Access Compliance Report Public Rights-of-Way (Curb Ramps)

Main Street: KELLOGG_DR Cross Street: MOUNTAIN_VIEW_AVE Location: SW

ADA ID: RPAT210922125709 Ramp Type: Type 1 - Perpendicular Diagonal Initial Pass/Fail: Pass Overall Compliance: No Severity Score: 2

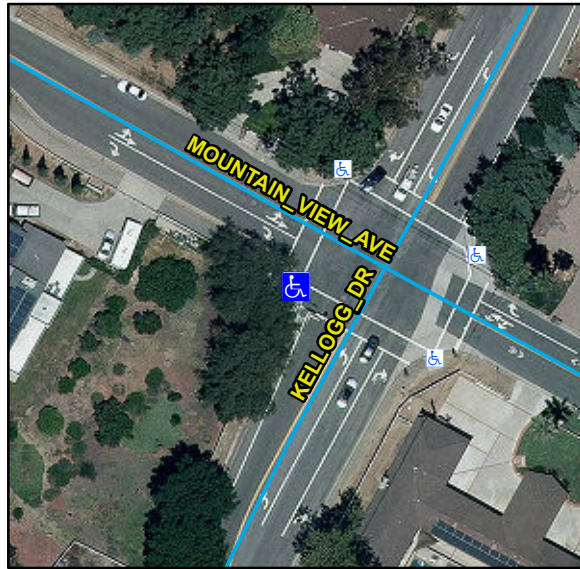
Compliance	Description	Data	Compliance	Description	Data
N/A	Ramp Length (in)	106	N/A	Flare Type LT	
Yes	Ramp Width (in)	48			Sloped
Yes	Ramp Run Slope (%)	6.9	N/A	Flare Slope LT (%)	6.4
No	Ramp Cross Slope (%)	4.3	N/A	Flare Traversable LT	No
N/A	Landing Present	Yes	N/A	Flare Type RT	
N/A	Landing Length (in)	70			Sloped
Yes	Landing Width (in)	48	Yes	Flare Slope RT (%)	5.7
Yes	Landing Run Slope (%)	1.4	N/A	Flare Traversable RT	Yes
No	Landing Cross Slope (%)	4.7	Yes	DWS Provided	Yes
N/A	Landing Movement Obstructed?	No	Yes	DWS Contrast	Yes
	Landing Movement Type	N/A	Yes	DWS Length (in)	36
N/A	Landing Shared	No	Yes	DWS Full Width	Yes
Yes	Clear Space	Yes	Yes	DWS Offset Left (in)	0
Yes	Clear Space To Crosswalk (in)	48	Yes	DWS Offset Right (in)	N/A
N/A	Marked Crosswalk 1	Yes	N/A	Marked Crosswalk 2	Yes
	Crossing 1 Direction	SE		Crossing 2 Direction	NE
	Marked Crosswalk 1 Width (in)	120		Marked Crosswalk 2 Width (in)	120

Yes	Ramp Inside Crosswalk 1	Yes	Yes	Ramp Inside Crosswalk 2	Yes
	Crossing 1 Slope (%)	4.4		Crossing 2 Slope (%)	5.4
	Crossing 1 Cross Slope (%)	5		Crossing 2 Cross Slope (%)	0.9
Yes	Gutter Ponding	No	No	Curb Slope	10.6
Yes	Gutter Lip Height (in)	0		Road Run Slope (%)	1
Yes	Gutter Run Slope (%)	4.3		Road Cross Slope (%)	6.6
No	Gutter Cross Slope (%)	8.5			
Yes	Overall Surface Condition: Acceptable		Yes	Perp Joint Present	Yes
	Cross Gutter Present?	No		Spandrel Present?	No
	Replace Cross Gutter?	N/A		Replace Spandrel?	N/A

Remove & Replace Curb Ramp With Two New Directional Ramps or Equivalent. Remove & Replace Gutter.
